SUBMITTAL IDENTIFICATION SHEET

WEBSTER UNIVERSITY ISB
PROJECT NAME

RE: Stainless Steel Courtyard Stair Rails Shop Drawings

WEST COURTYARD STAIR - REF A0508.A

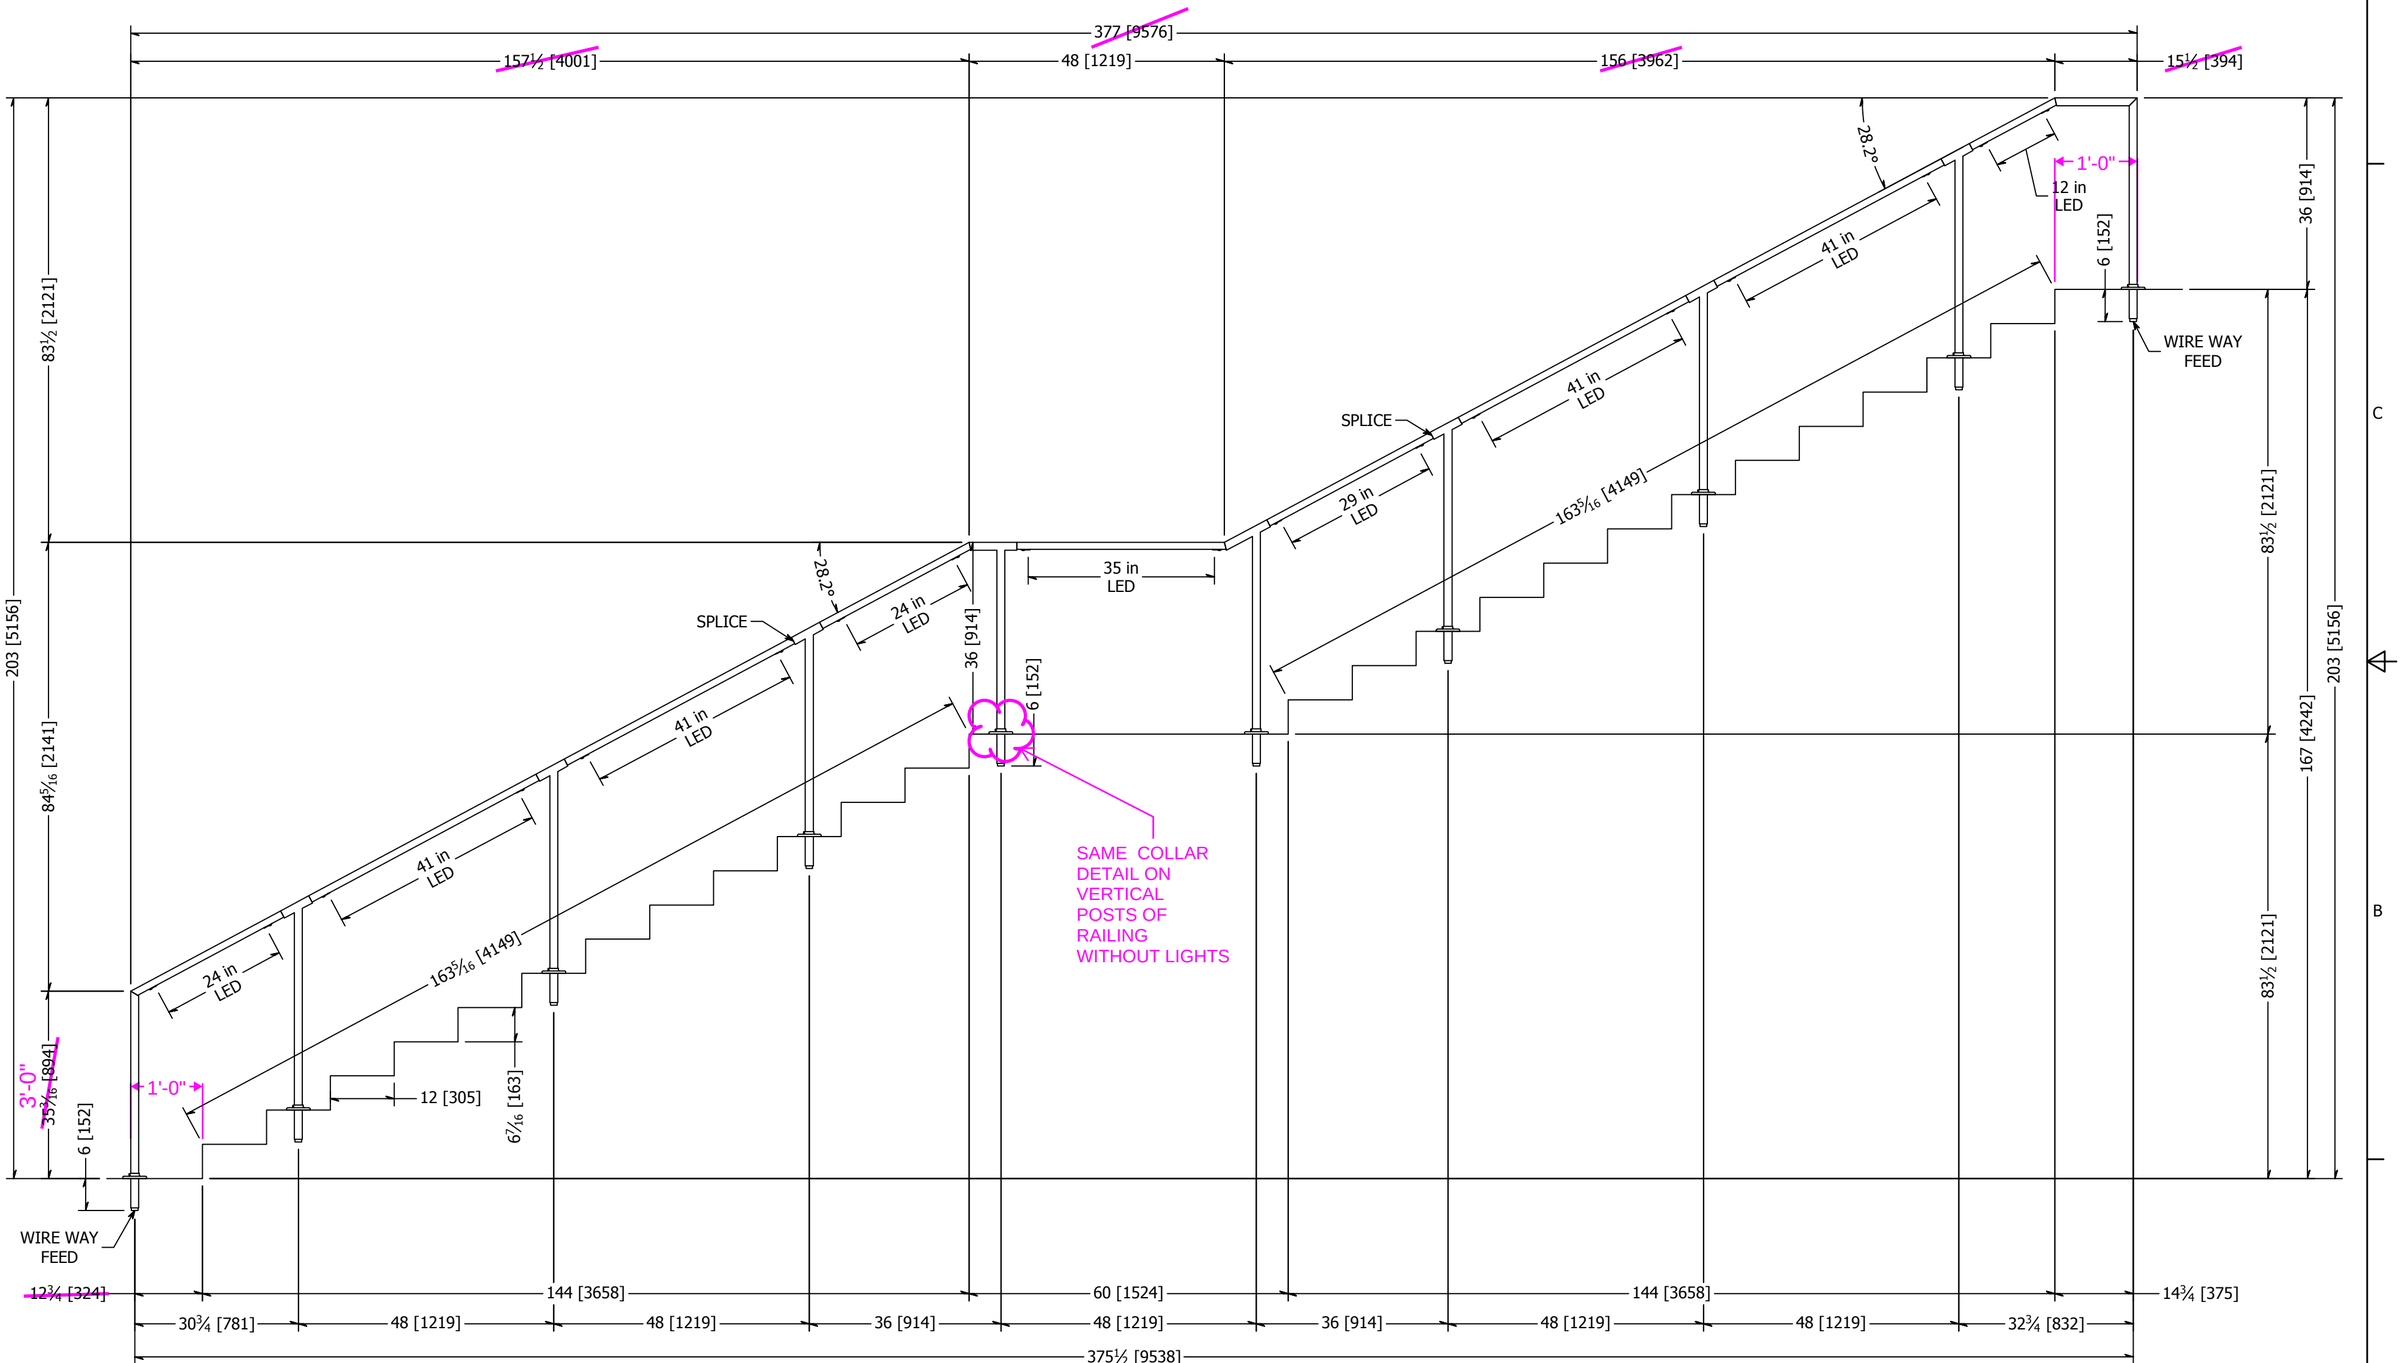
ALL VERTICAL POSTS OF HANDRAILS ON BOTH SIDES OF STAIR -
WITH INTEGRATED LED LIGHTS AND WITHOUTS LIGHTS, MUST ALIGN.
